Rezoning Transportation Analysis
Petition Number: Insert Zoning Petition #2021-213
General Location Identifier: 22706130

Revision Log:	Date	Revision Log:
	01/21/2022	First Review (WB)

Transportation Summary

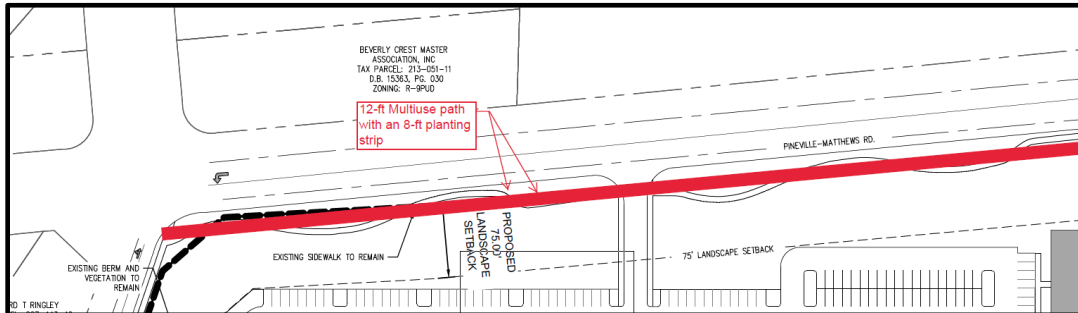
- Site plan and conditional note revisions are needed to commit to constructing two accessible curb ramps on the southeast corner of the Hugh Forest Road intersection per PROWAG and ADA law. Commitments to include all necessary works to bring the pedestrian crossing into ADA and PROWAG compliance, including crosswalk restriping.

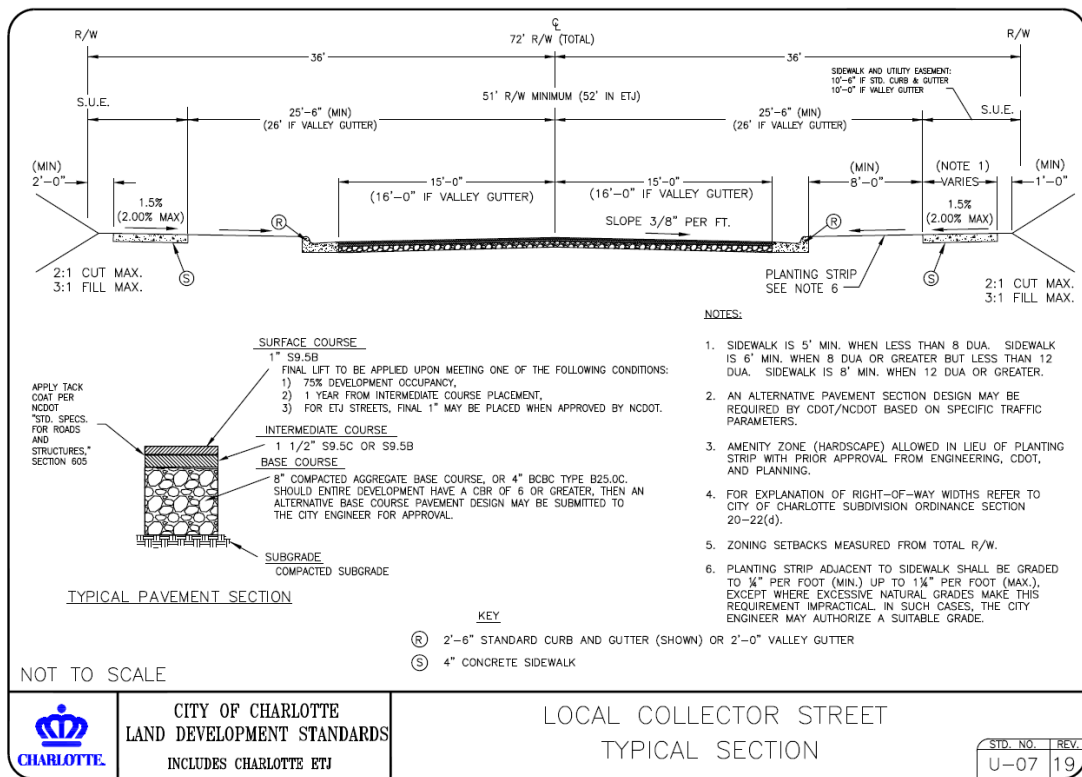
- Site plan and conditional notes revisions are needed to commit to construct bicycle facilities by installing a 12-foot multi-use path along the site's entire Pineville-Matthews Road frontage in accordance with the Charlotte BIKES Policy.

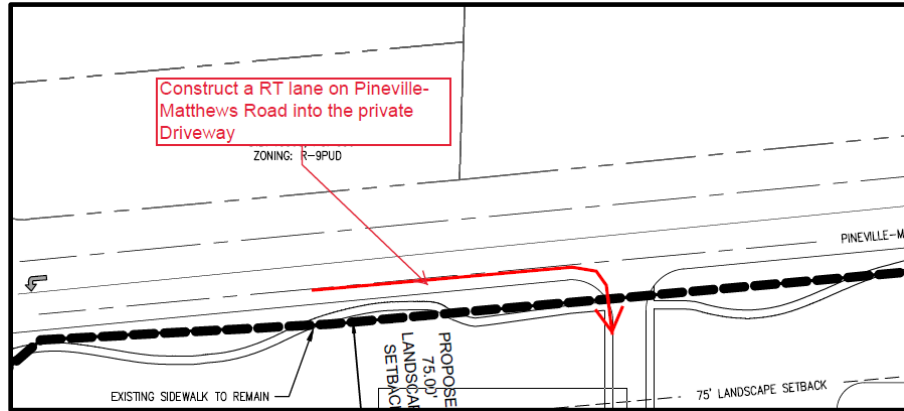
- The proposed dwelling units exceeds 12 per acre. Per Chapter 20 Subdivision ordinance, site plan and conditional note revisions are needed to commit to construct an 8-foot sidewalk with an 8-foot planting strip along Hugh Forest Road. The wider sidewalk also meets the Charlotte WALKS Policy.

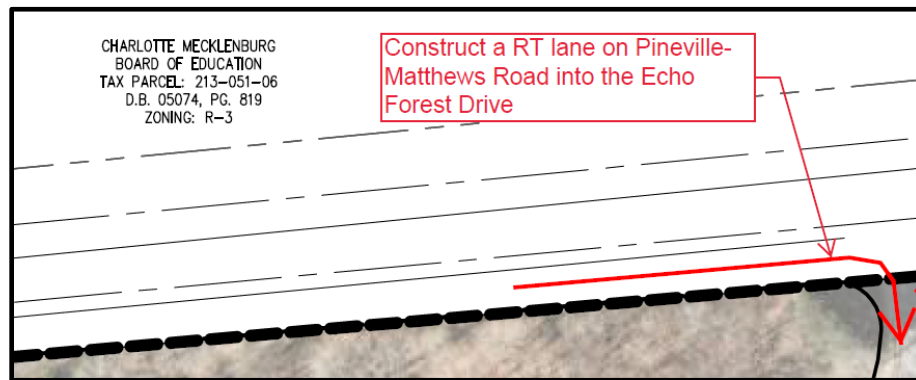
- 7. Revise site plan and conditional notes to commit to constructing a right turn lane on Pineville-Matthews Road into the proposed driveway per NCDOT standards.

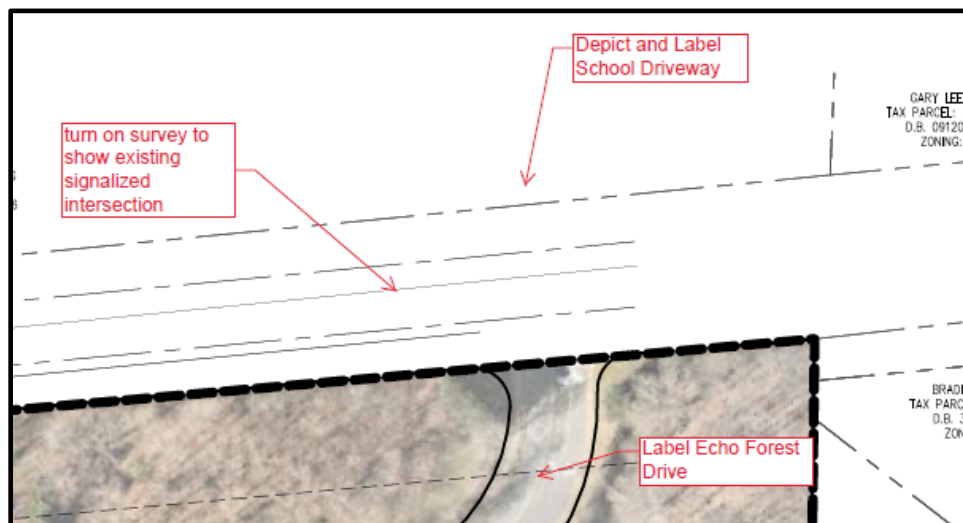
- 8. Revise site plan and conditional notes to commit to constructing a right turn lane on Pineville-Matthews Road into the Echo Forest Drive per NCDOT standards.

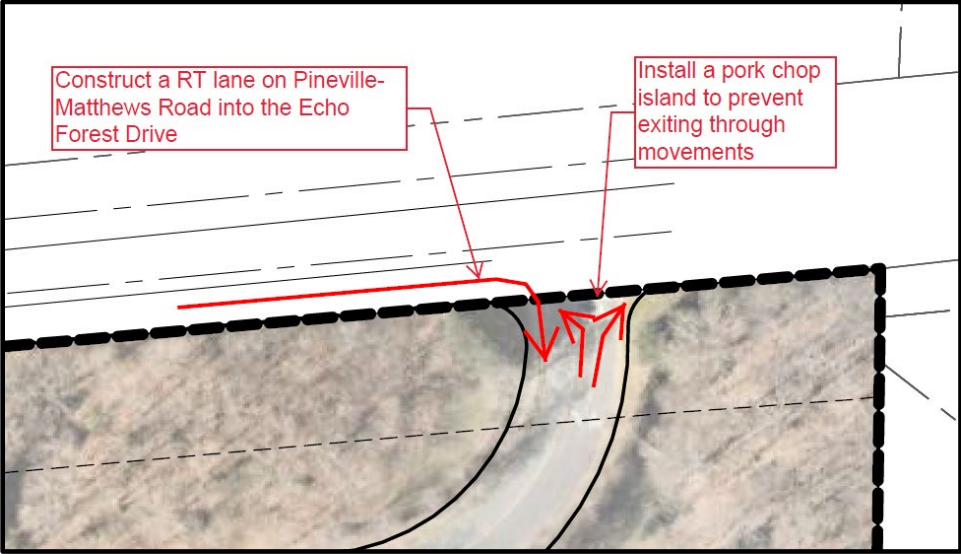
- 9. Revise site plan to adequately depict and label existing facilities, including the Echo Forest Drive, the signalized intersection at Echo Forest Drive, and the existing School Driveway.

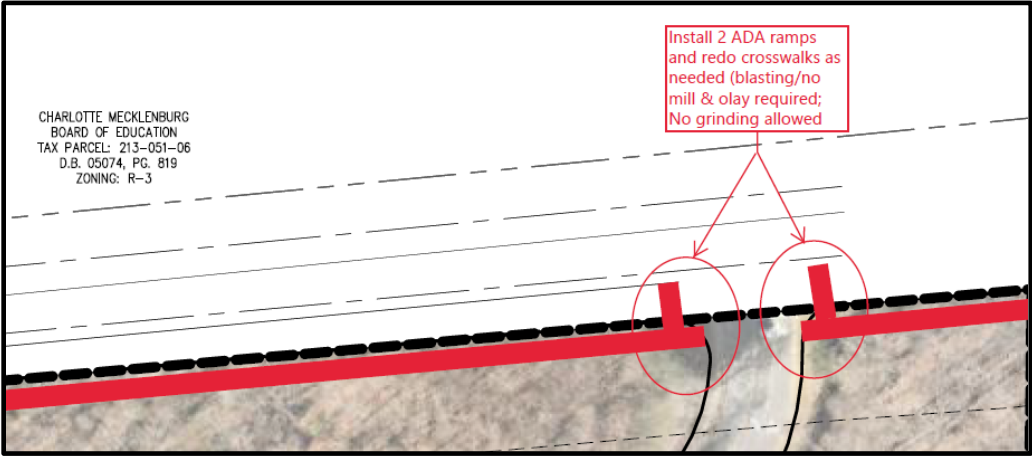
- 10. The egress movement at Echo Forest Drive shall be limited to 'left out and right out' only to mitigate the increase in traffic at the existing signalized intersection. No northbound through movements will be encouraged. Petitioner to install a concrete channelization island per NCDOT standards to enforce the restricted movement.
